BROIL ELEMENTS

SOLID STATE RELAYS

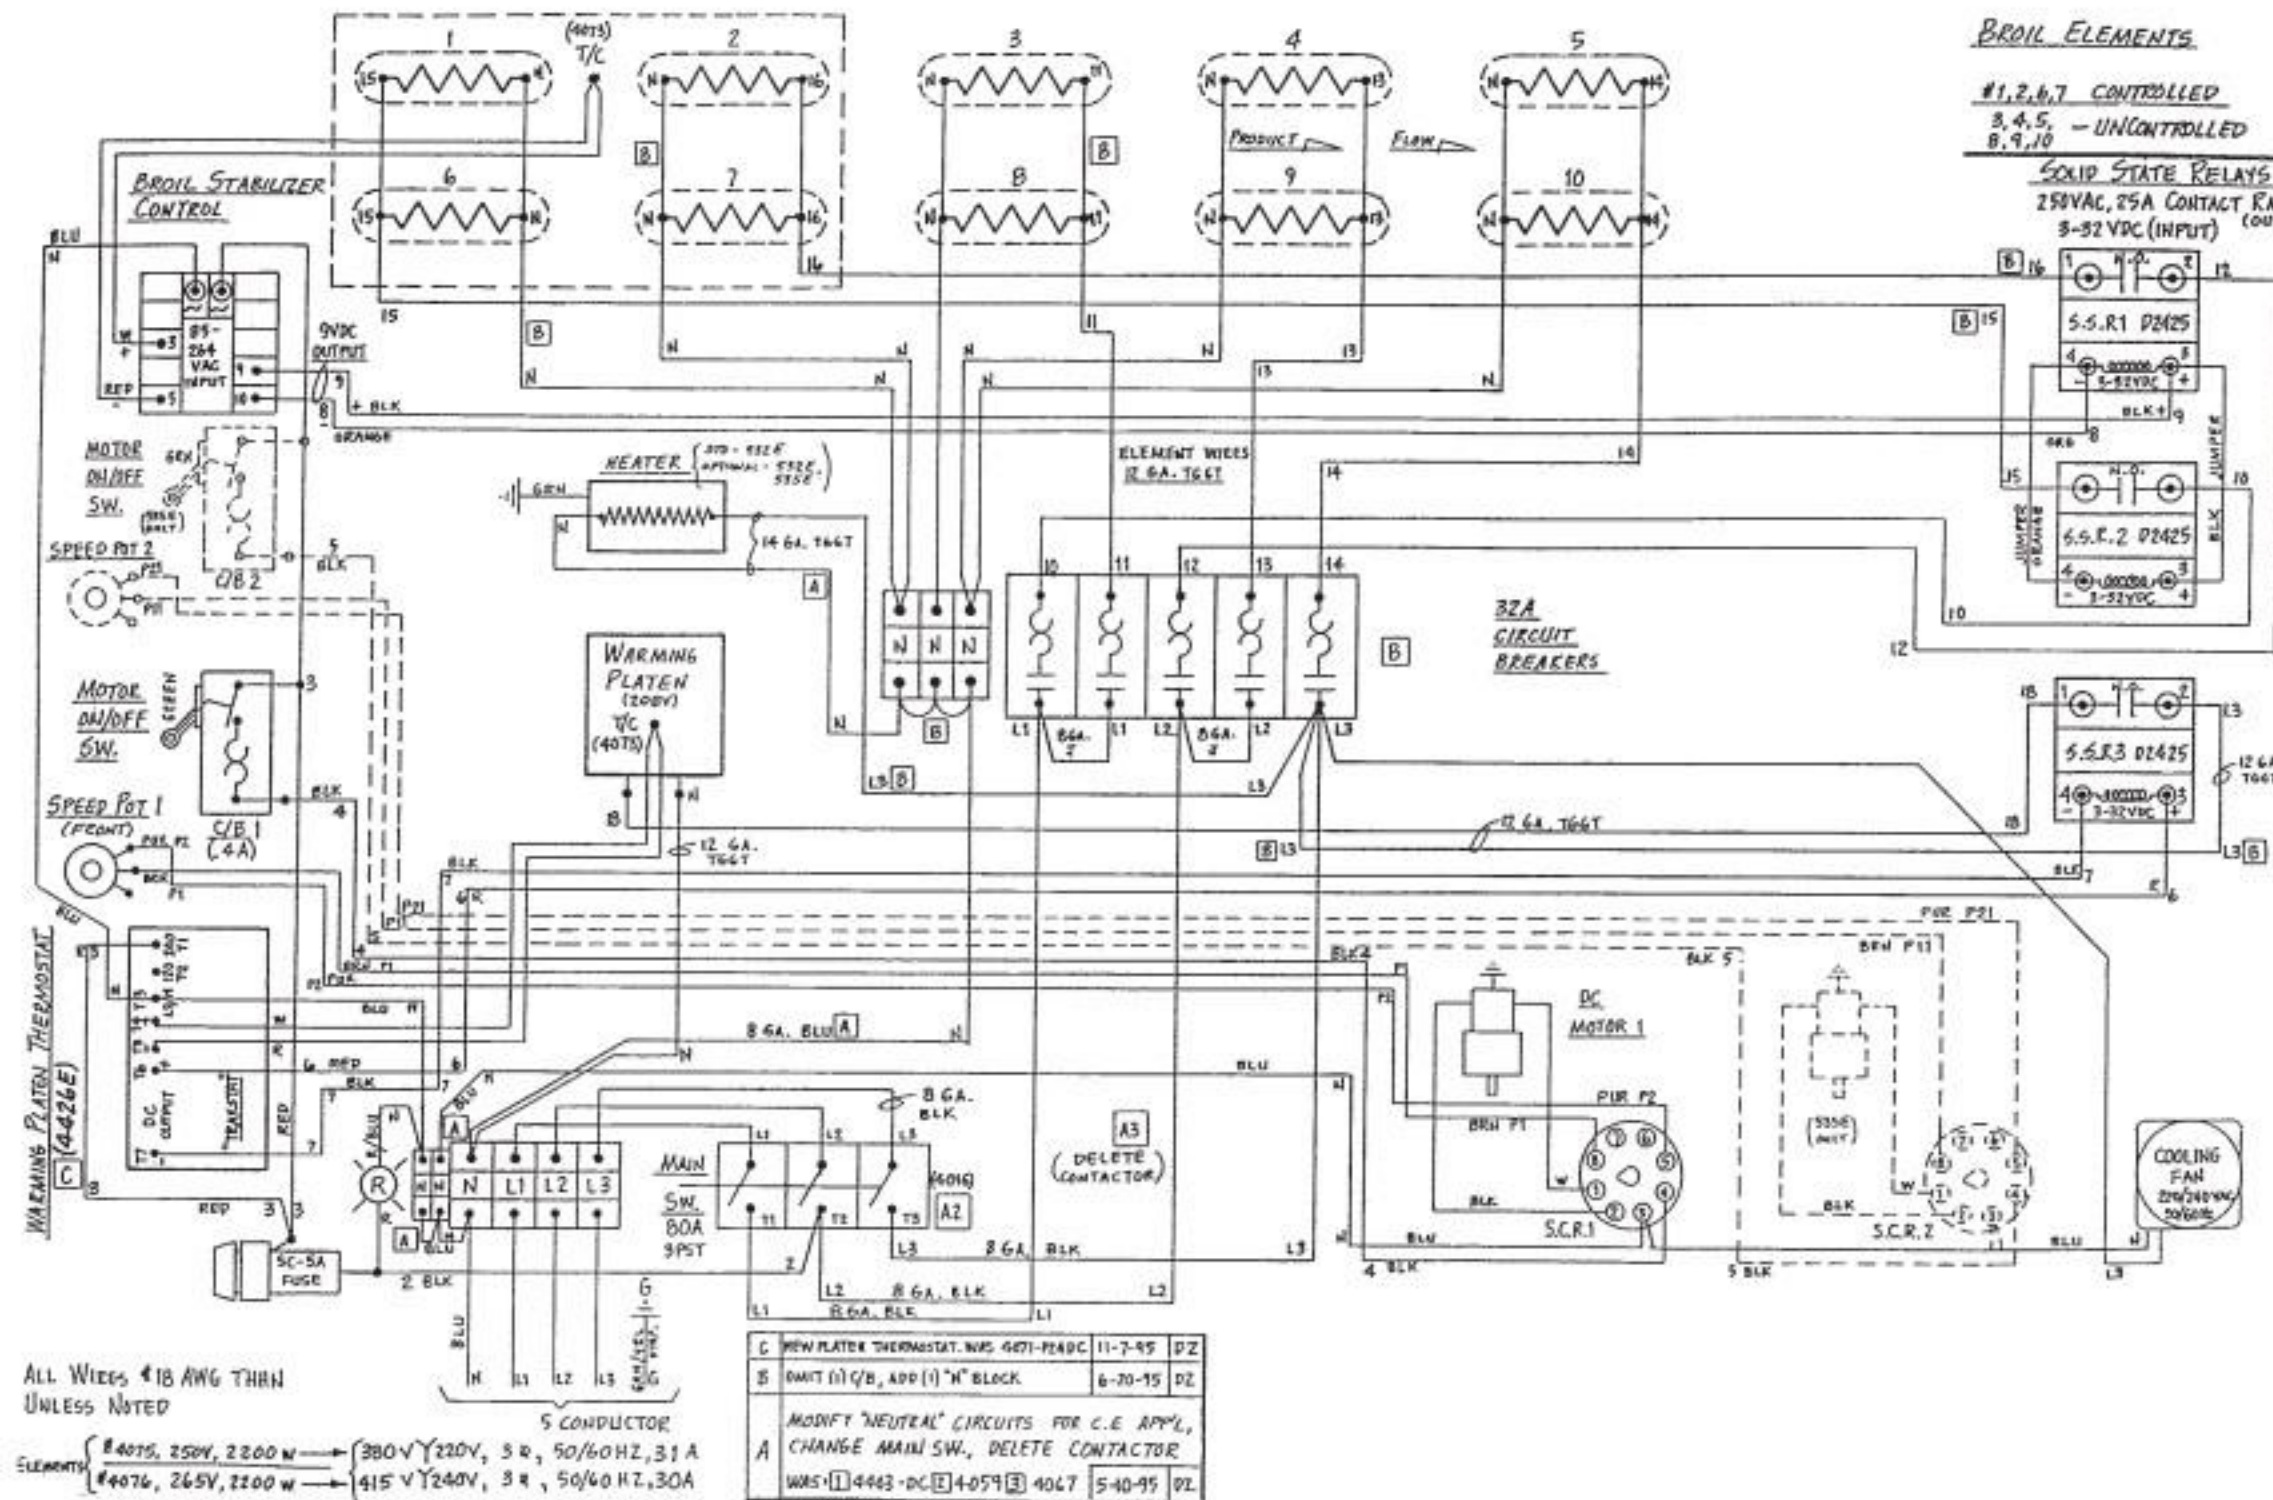
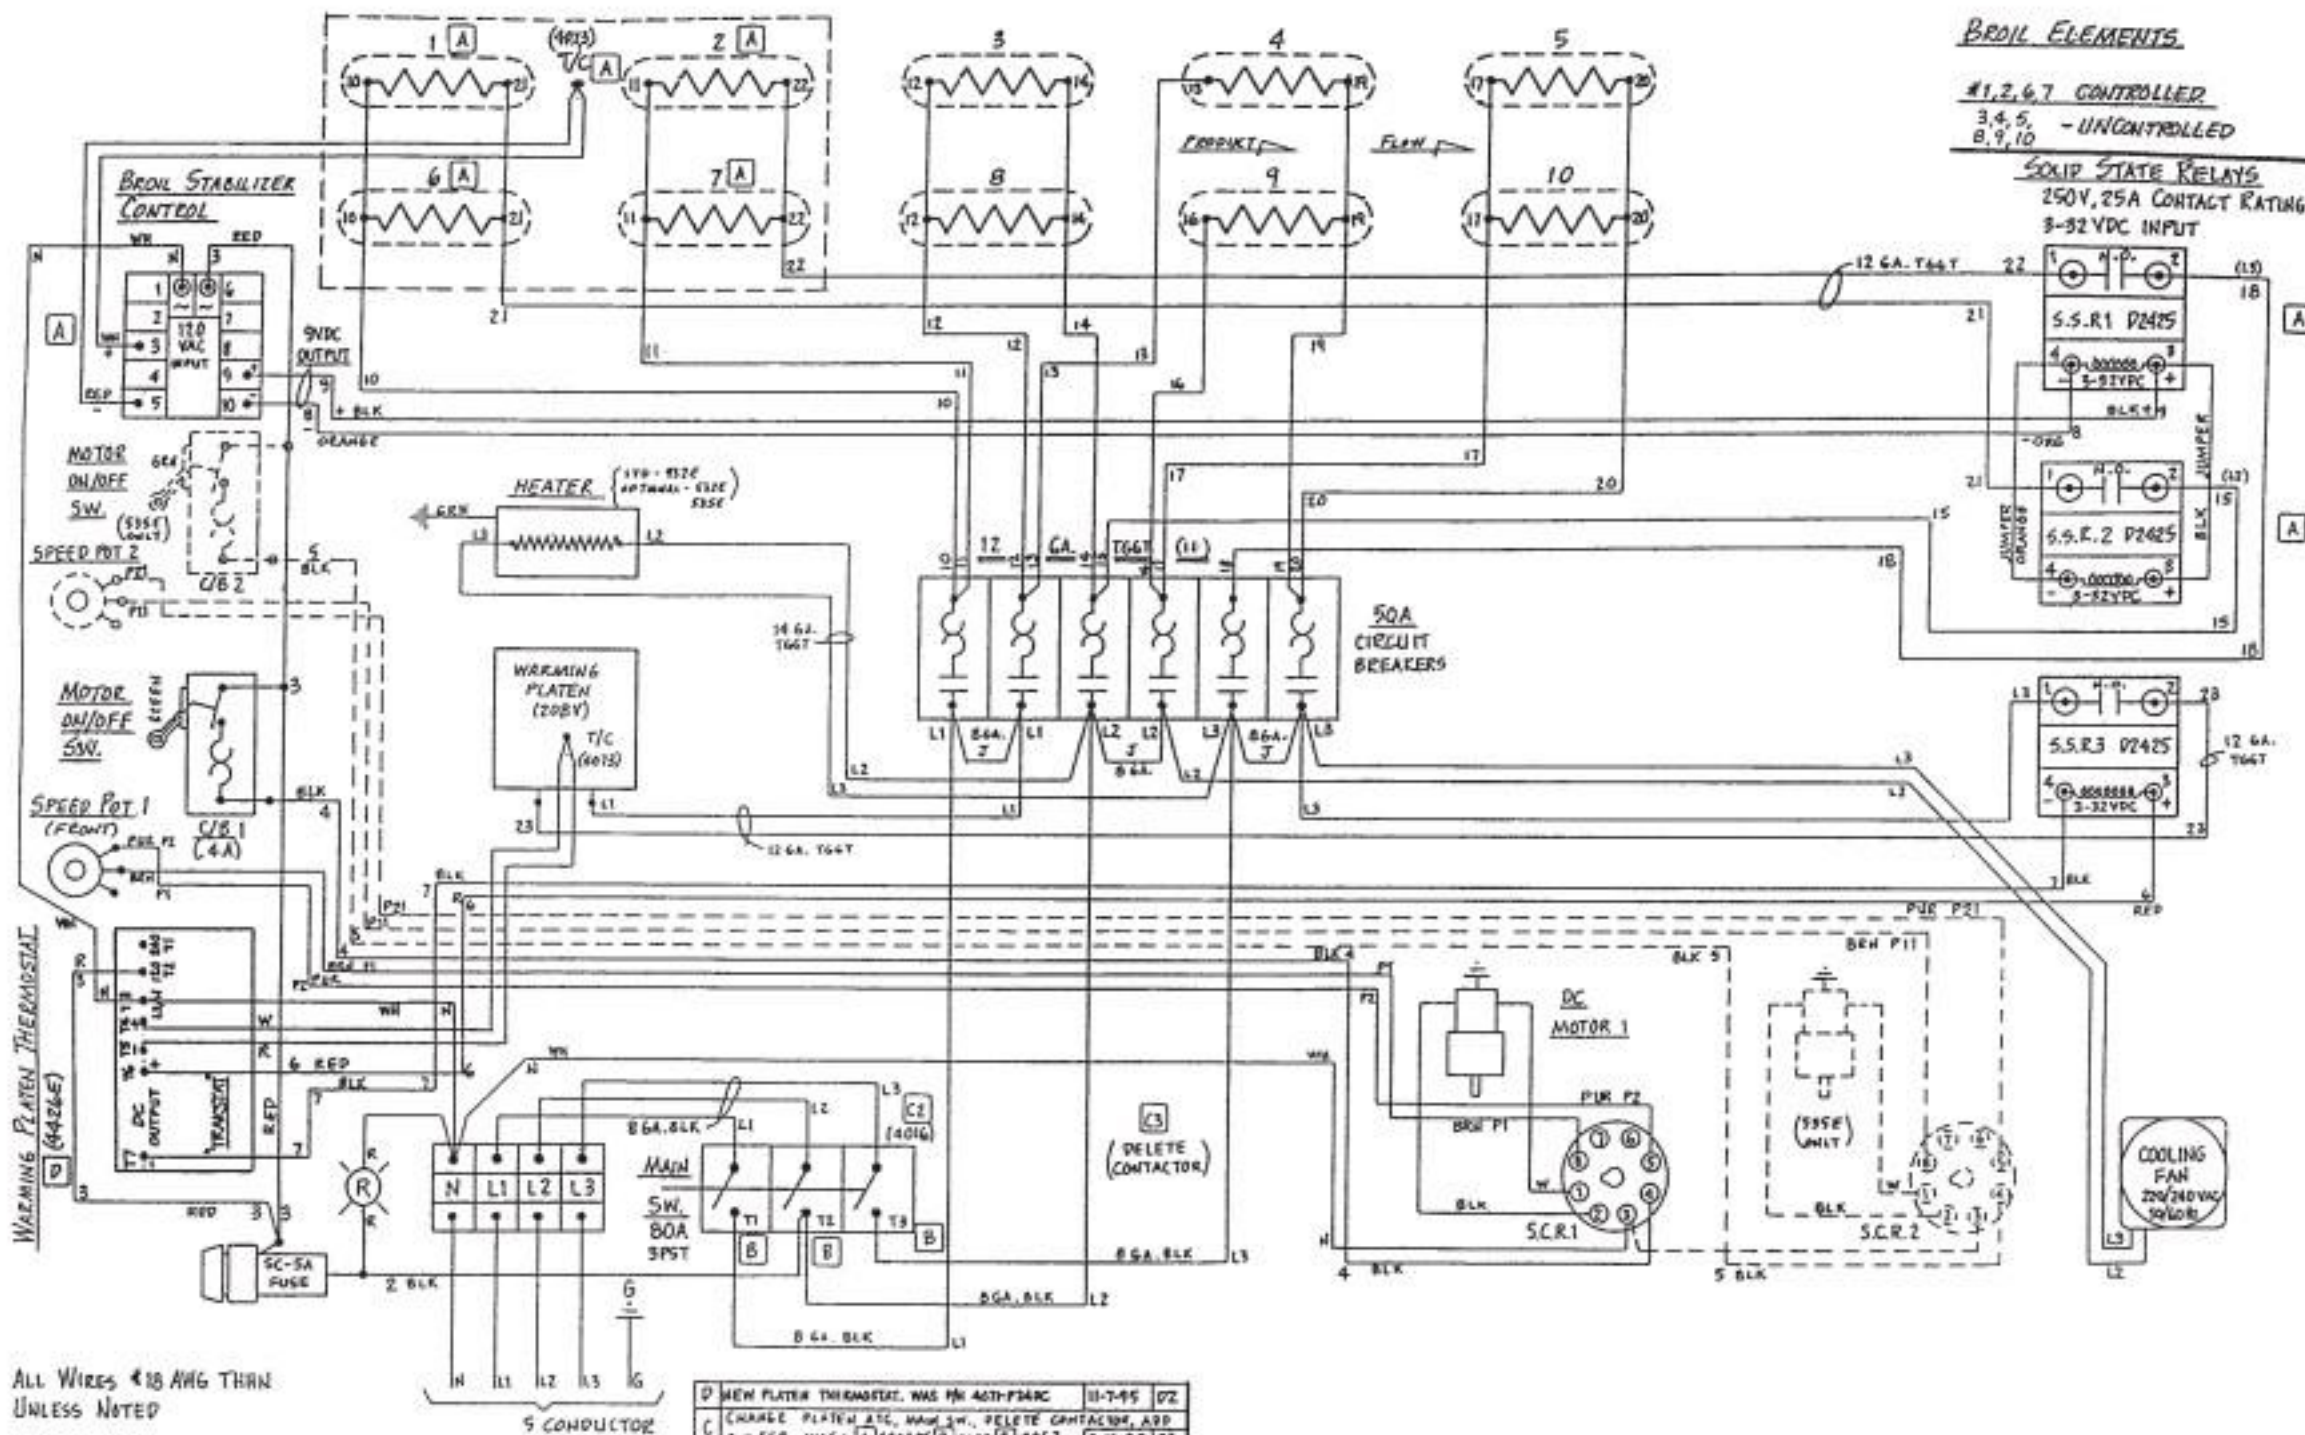
D	NEW PLATEN THERMOSTAT, WAS PN 40TH-P24RC	11-7-95	DZ
C	CHANGE PLATEN ATC, MAIN SW, DELETE CONTACTOR, ADD 2ND SCR, WAS: 1) 4049K/2) 4054/3) 4067	5-10-95	DZ
B	RE-LABEL CONTACTOR FOR U.L.	3-6-74	DZ
A	RE-CON. WAS: (6) ELEMENTS, (1) ATC, (1) SSR, (1) T/C	7-14-93	DZ

A	NEW FLATEN THERMOSTAT, DELETE C/B JUMPER, INCREASE WIRE SIZE, NO. 6 (1) P/N 4471-P240C (2) 6 GA. (11-7-95) PT
---	--
